Pukenui Solar Farm

Section 127 Application to Vary Resource Consent Conditions

WWLA0995 | Rev. 1

15 August 2024

DRAWING No.: **PUK-L-1011-GA-011** REV.: **C**

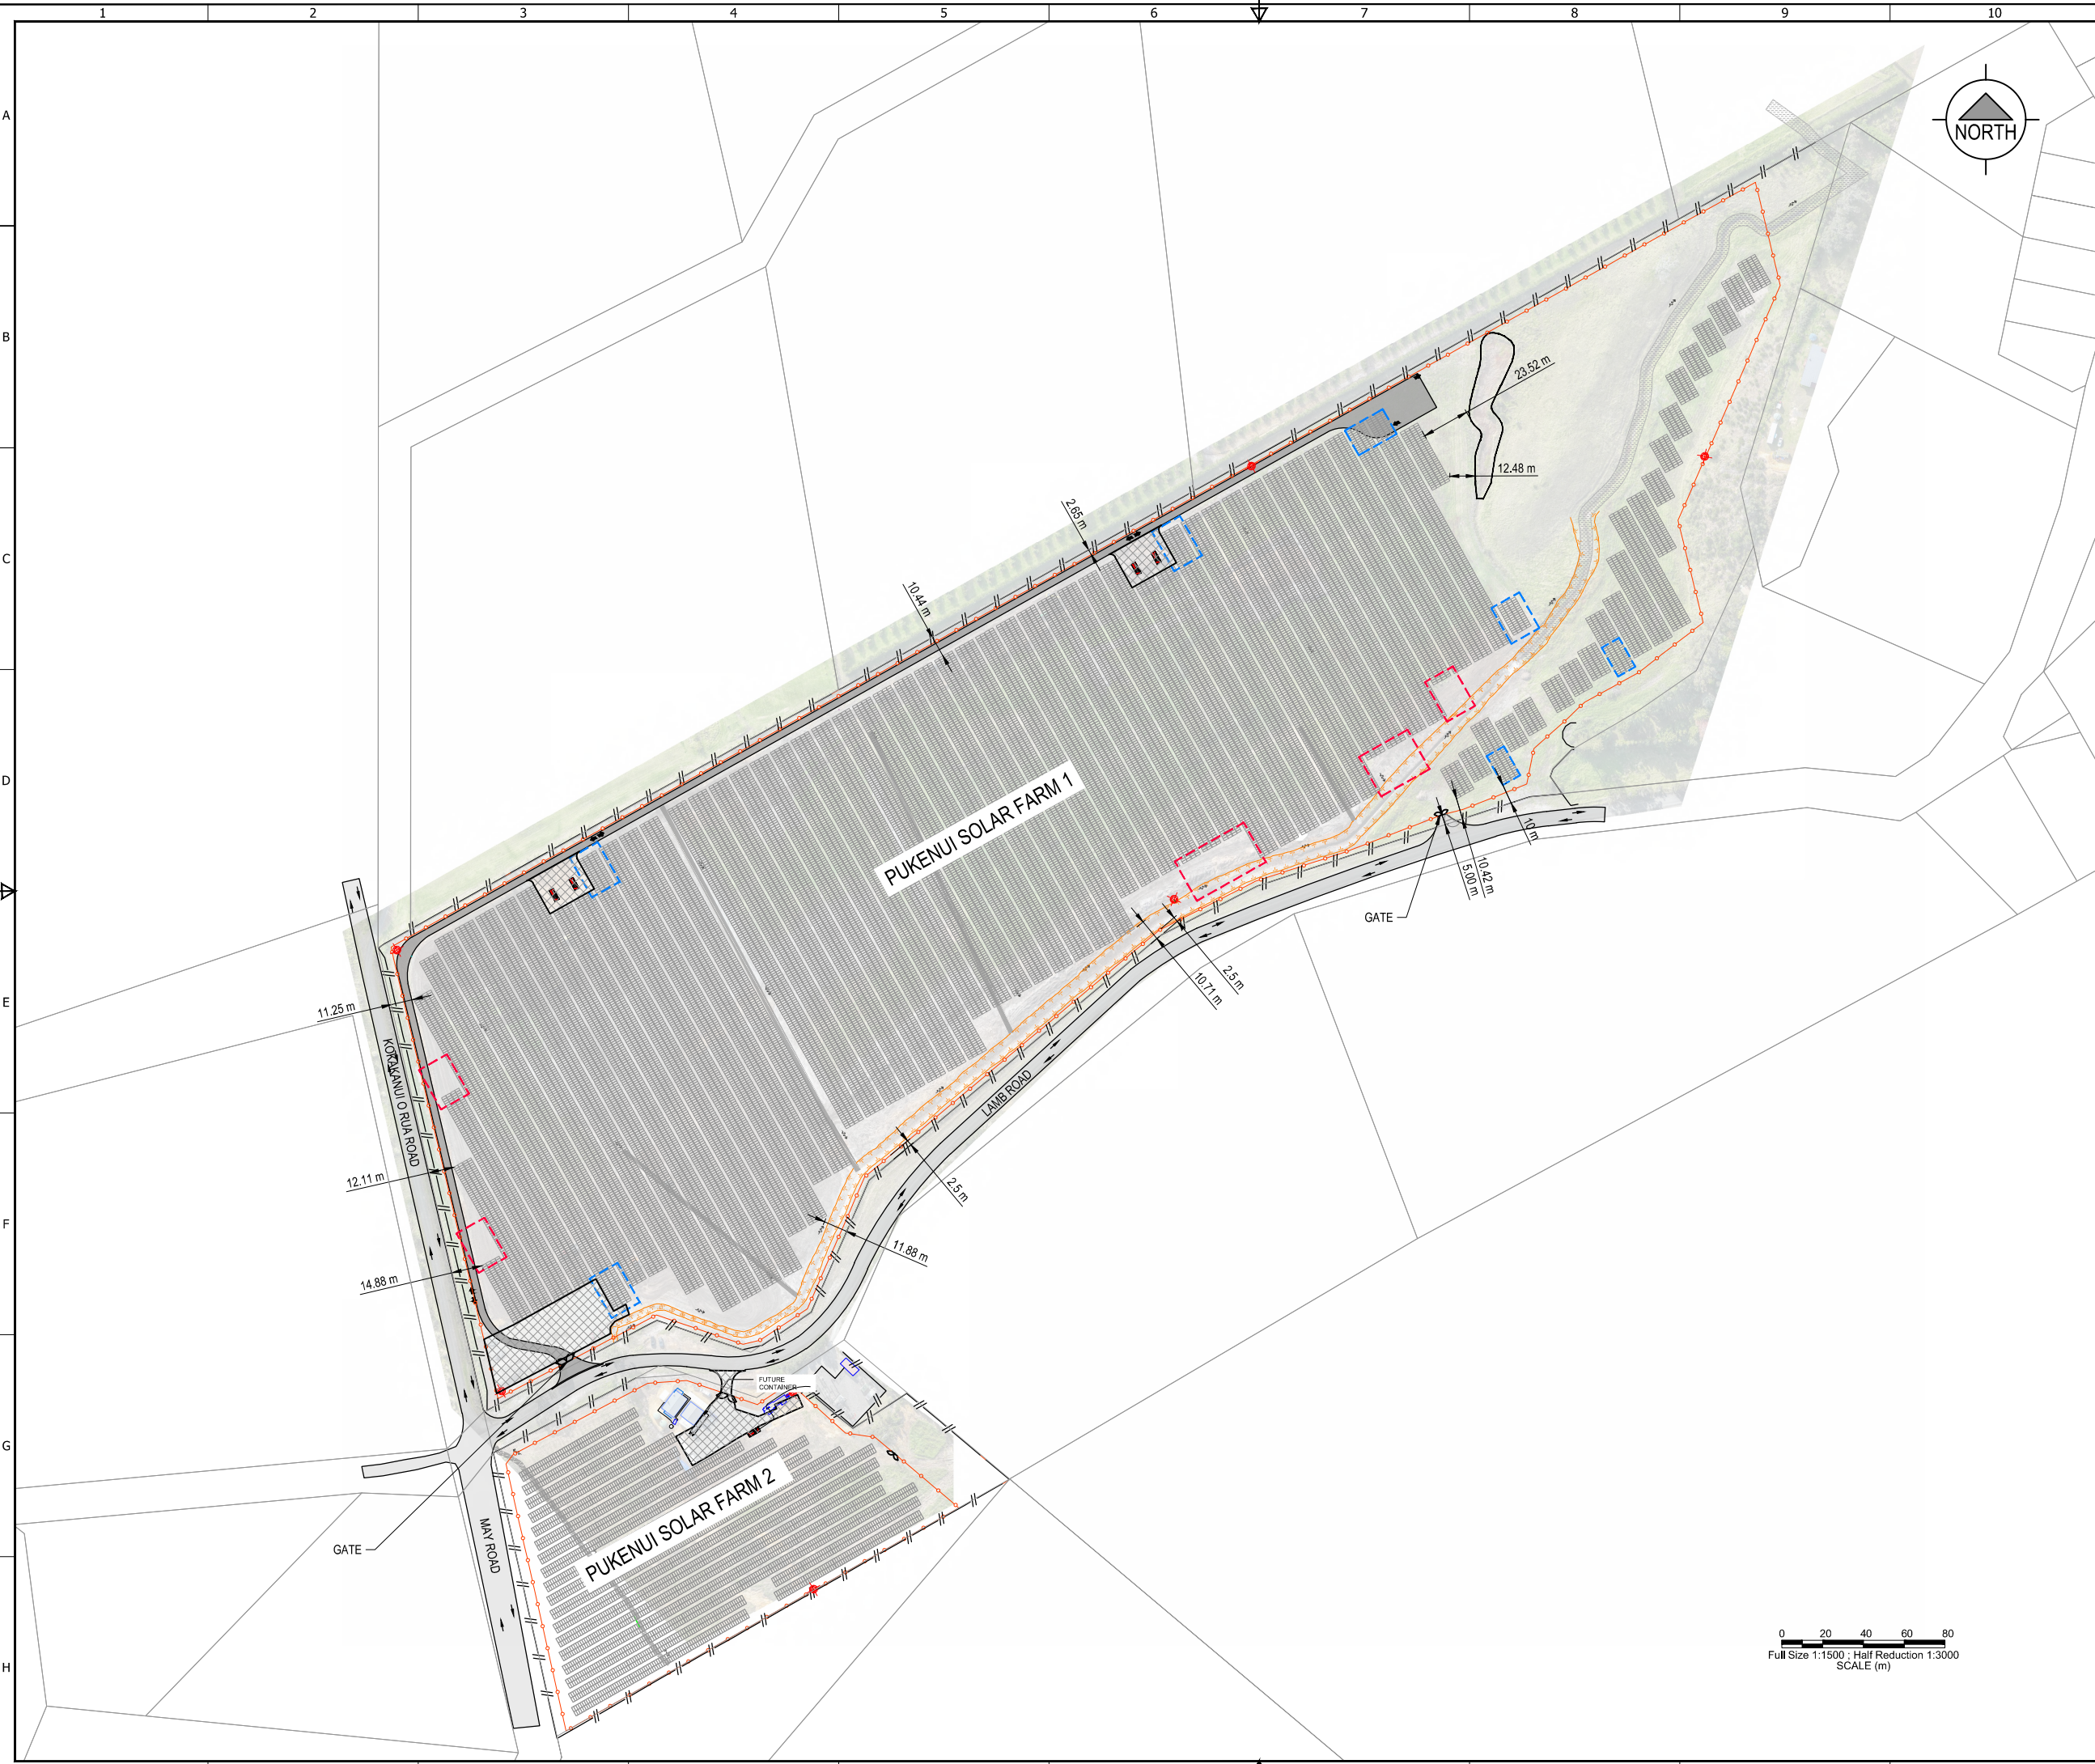
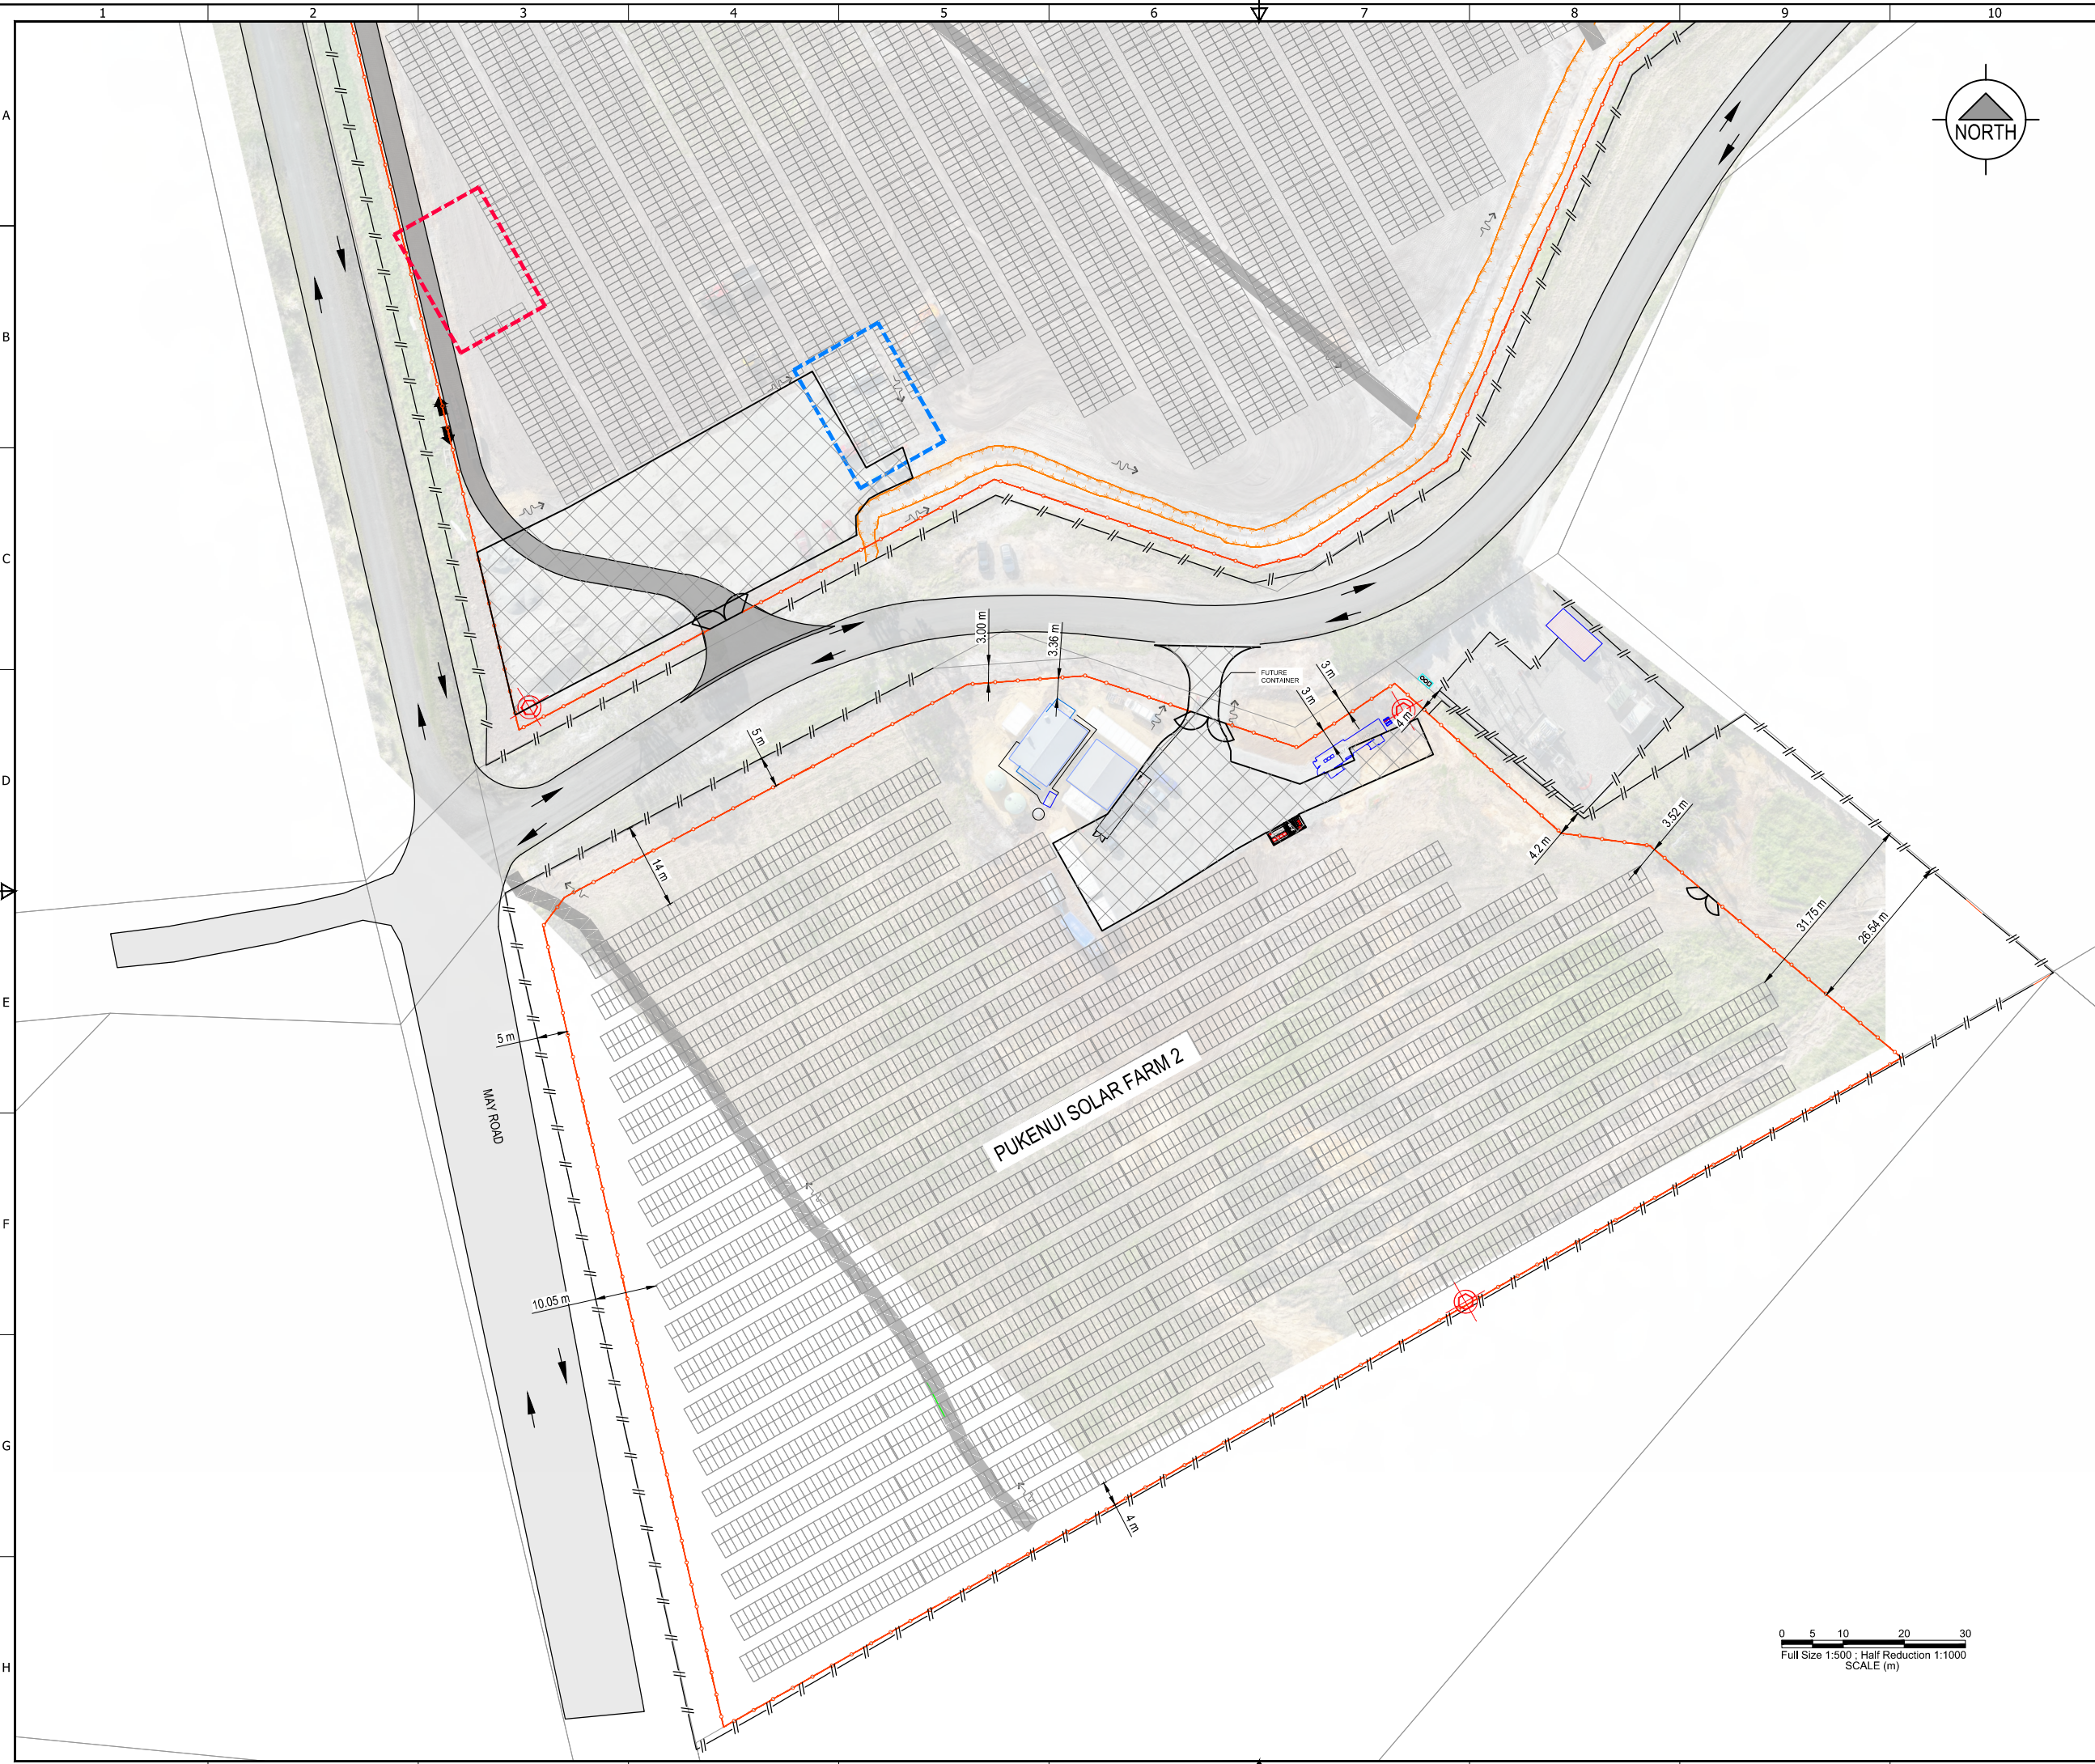
- **Site Layout** – Minor changes to the location of solar panels to enable the provision of a larger drainage channel within the site, with change in orientation of the Inverter PCU on the north side of Pukenui 1. The solar array proposed will be similar to that approved and details of this are provided in the revised Site Layout Plan in **Appendix D**.

1. The activity shall be carried out in accordance with the plans prepared by Pukenui-1 Solar Site Layout Plan (PUK-L-1011-GA-011-~~J00795-PK-0-DWG-G003-01~~PUK-1), Revision ~~BC~~ dated ~~25/10/2023~~11/07/2024 and attached to this consent with the Council's "Approved Stamp" affixed to it.
2. The activity shall be carried out in general accordance with the assessment and approved plans prepared by Simon Cocker Landscape Architecture, referenced Landscape, Memorandum dated 14 August 2024 ~~1st November 2023~~, and attached to this consent with the Council's "Approved Stamp" affixed to them:
 - i. Landscape Plan-Figure 2b: The Proposal Landscape Mitigation
